# DESIGN REPORT

## Westlink Stage 2, Kemps Creek – Naturalised Trunk Drainage Channel Design

**APPENDIX A Agency Response to Submission  
For ESR Stage 2 Trunk Drainage Channel**

**ESR WESTLINK STAGE 2  
RESPONSE TO SUBMISSIONS**

Plate 3-1 – Typical Channel Cross Section

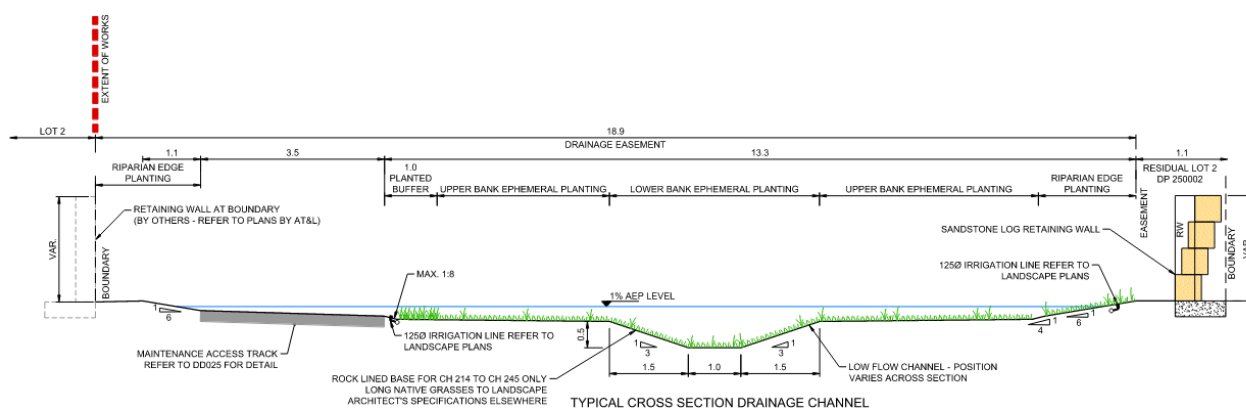
A	The channel as shown in the sketch below will have flows impacting the base of the retaining walls. This is considered a potential point of failure and should be designed to align with the Design Guidelines.	Trunk Drainage	The proposed Drainage Stage 2 channel typical cross section has been modified to ensure 1% AEP flows are contained within the channel batters consistent with Sydney Waters standard channel section details. Refer to JWP Plan no CD016 for details of the supporting hydraulic calculations.
A	<p>"The peak 1% AEP are at a maximum of 7.4m<sup>3</sup>/s at the Mamre Road end. According to the design guideline, the channel should therefore be 25m wide</p> <ol style="list-style-type: none"> <li>20m - 4.5m<sup>3</sup>/s</li> <li>25m - 11m<sup>3</sup>/s</li> <li>30m - 20m<sup>3</sup>/s</li> </ol>	Trunk Drainage	An 18.9 m wide channel is proposed and this is supported by detailed hydraulic assessment that demonstrate its capacity and compliance with key design objectives, consistent with Sydney Waters Channel Design checklist (page 6). At the detailed design stage this will be further supported by TUFLOW 2D hydraulic modelling and mapping that assesses velocity and shear stresses at a suitable level of detail to support construction stage

A	As per design guidelines: "all corridors will require a 3.5m wide maintenance/ access track suitable for light vehicles. A 1m planted buffer is required adjacent to the access track"	Trunk Drainage	The required 1m buffer has been included on the channel typical section and is indicated on JWP Engineering plan CD016
A	Drop structure should be installed where a grade is at 2%. Please provide shear force modelling to inform if drop structure are required. Erosion protection to be provided as an alternative to drop structure	Trunk Drainage	The hydraulic assessment provided on JWP engineering Plan CD016 demonstrates that the short rock lined section meets performance requirements. The extent of rockwork of approx 120 m2 is a relatively small footprint and allows for an uninterrupted habitat along the channel length (unlike a drop structure and aprons)
A	Velocities and shear force at bank/retaining wall interface to be provided as this location is vulnerable to erosion	Trunk Drainage	The channel section has been modified to avoid flows impacting upon adjoining walls. Additional detailed shear stress modelling will be undertaken at the next design stage
